**METROPOLITAN GOVERNMENT OF NASHVILLE AND DAVIDSON COUNTY**

**STAFF RECOMMENDATION**  
**1610 Cedar Lane**  
**July 20, 2016**

**Application:** New construction—outbuilding  
**District:** Belmont Hillsboro Neighborhood Conservation Zoning Overlay  
**Council District:** 18  
**Map and Parcel Number:** 11704025900  
**Applicant:** Van Pond, Jr.  
**Project Lead:** Melissa Baldock, melissa.baldock@nashville.gov

Figure 3. The 1957 Sanborn Map shows a 2 story outbuilding in approximately the same location as is proposed

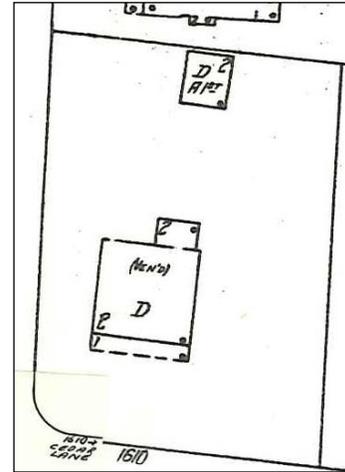
The proposed outbuilding meets all base zoning setbacks. This site does not have an alley, so accessing the outbuilding via an existing curb cut on Oakland Avenue (the side street) is appropriate. For corner lots like this one, the outbuilding should match the context of homes on the street, or be a minimum of ten feet (10') from the side street. In this case, the house next door at 2418 Oakland Avenue is approximately thirty-five feet (35') from the front Oakland Avenue property line (Figure 2). The applicant is proposing to put the new outbuilding approximately forty feet (40') from the Oakland Avenue property line. Staff finds that having the two-story outbuilding recessed five feet (5') from the front of the one-and-a-half story house next door to be appropriate, as it will lessen its prominence along the street. Staff notes that the 1957 Sanborn Map shows a two-story outbuilding in approximately the same location as is currently proposed (Figure 3).

Figures 4 & 5 show the significant slope of the lot.

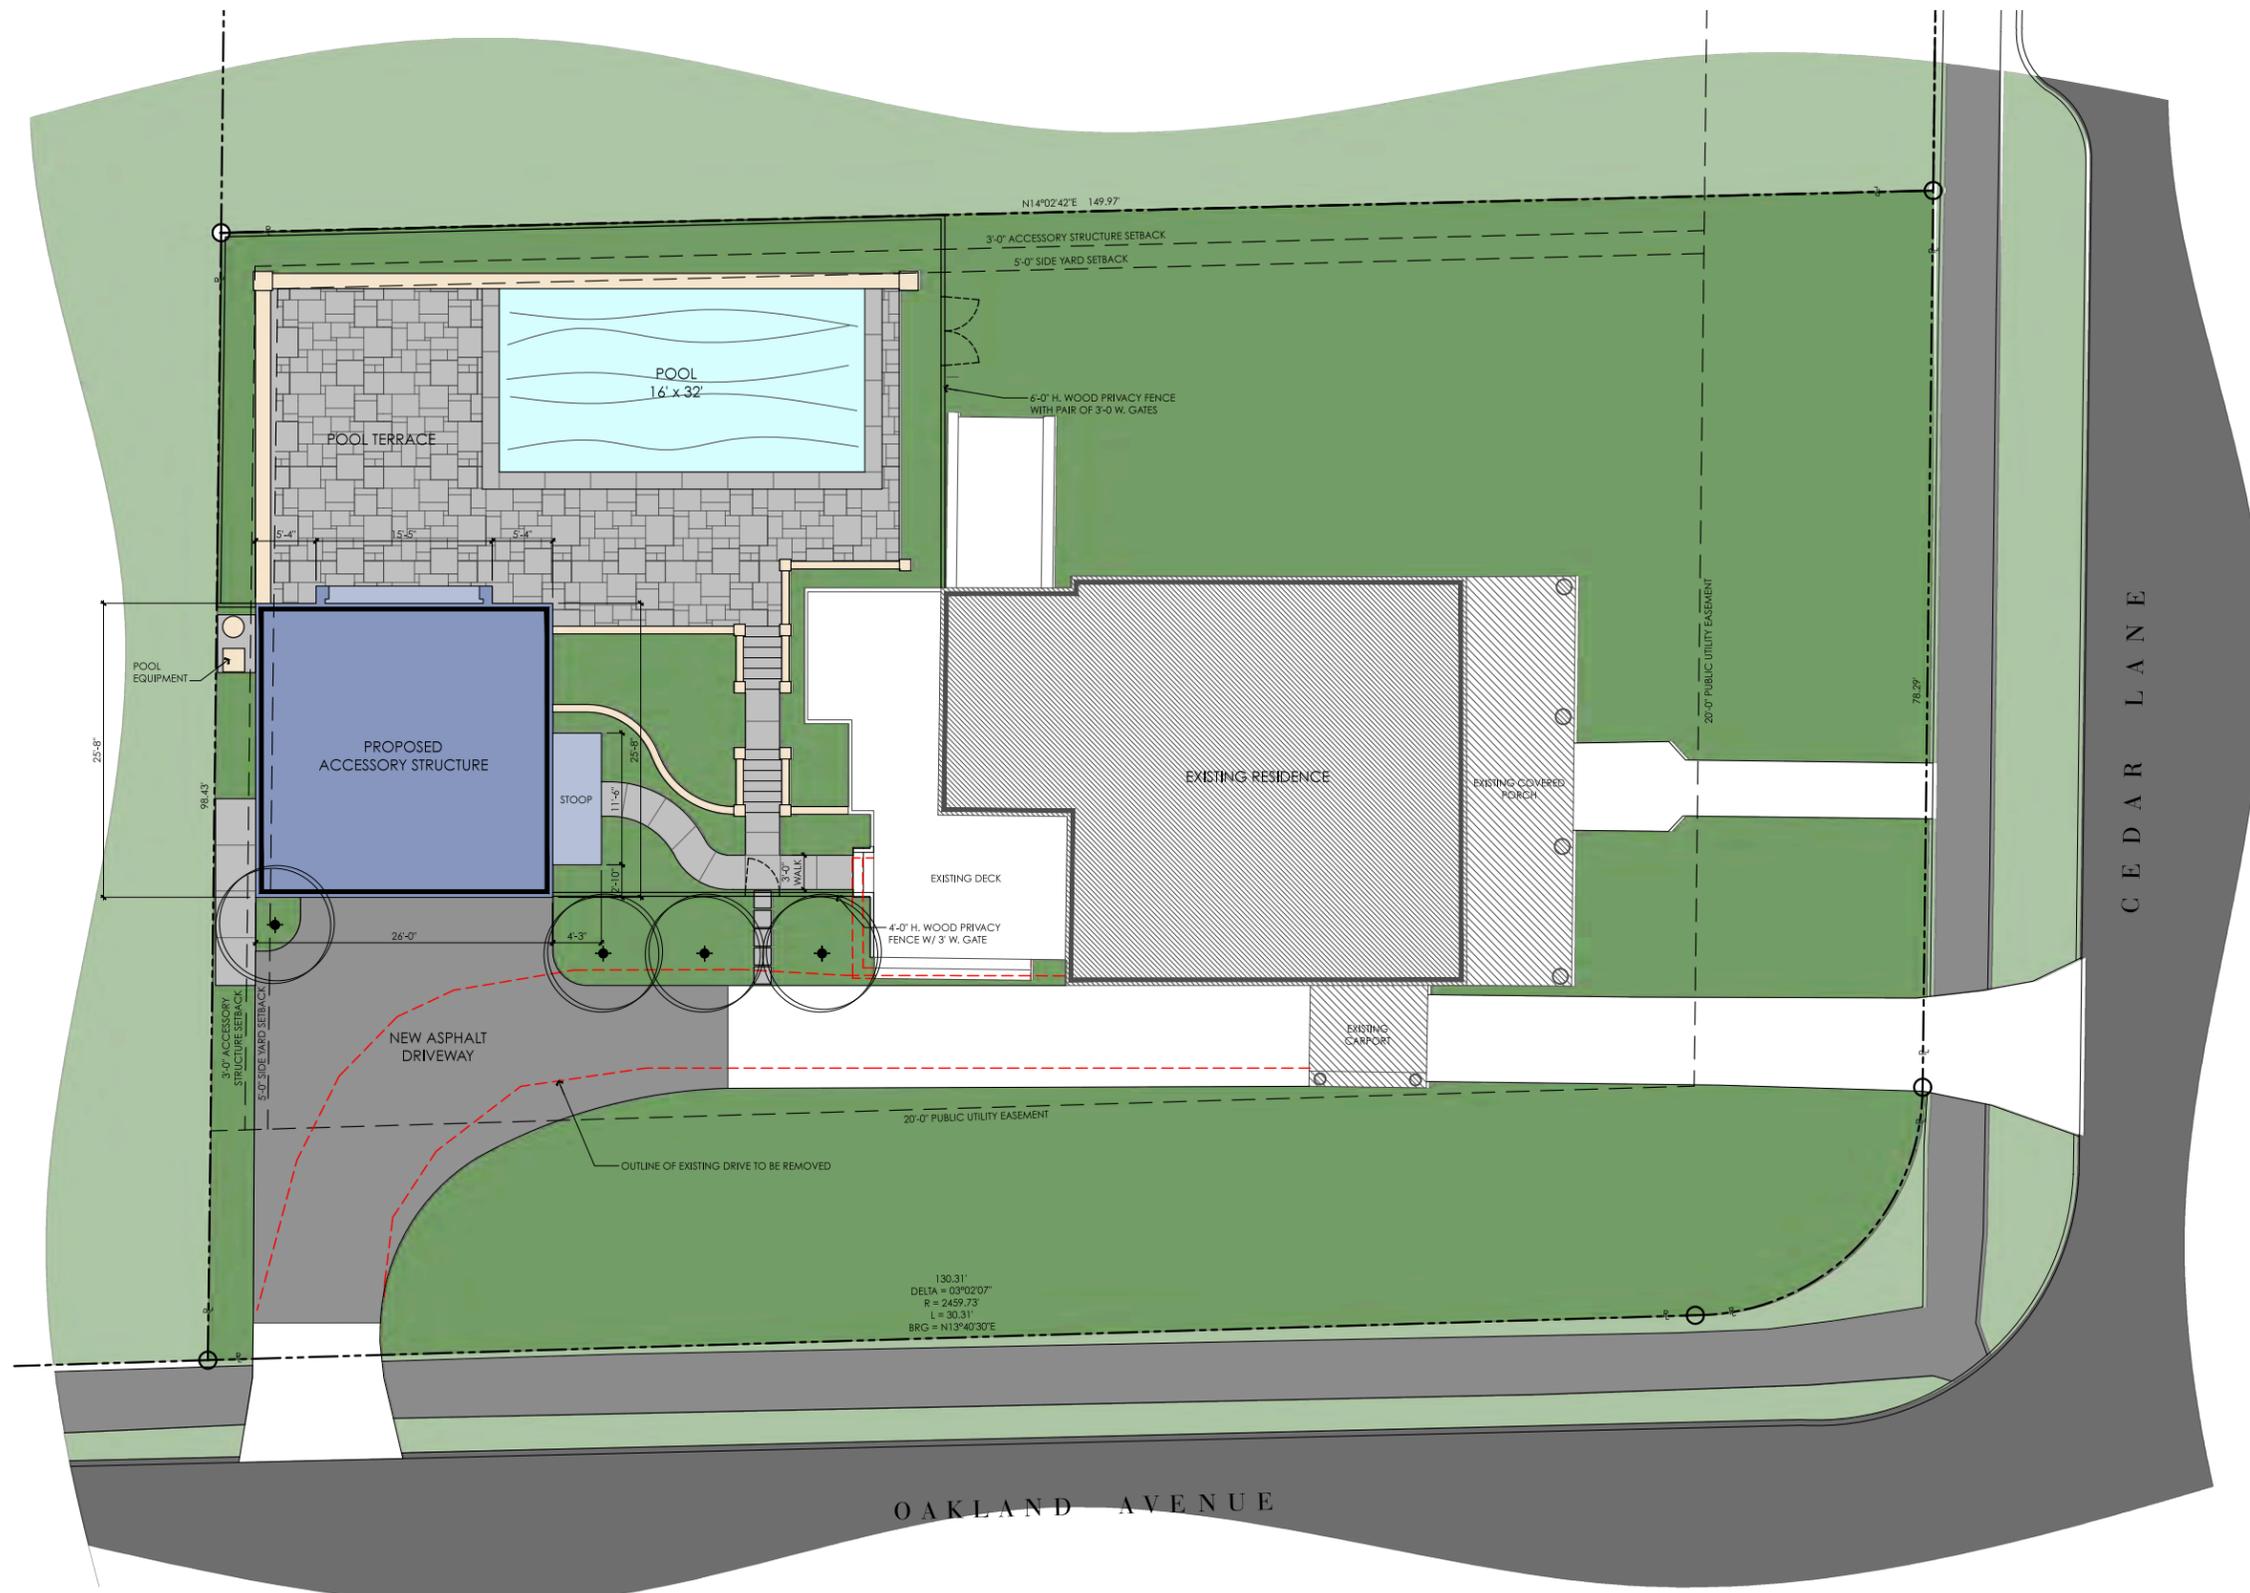
The lot slopes significantly down from the west/Oakland Avenue side of the lot to the east/interior portion of the lot (Figures 4 & 5). The eave and ridge heights used to compare the historic structure and the proposed outbuilding are taken from the finished floor line for consistency. The slope will require unusually tall eave and ridge heights for the interior side of the building but it will have an appropriate massing as seen from the street.
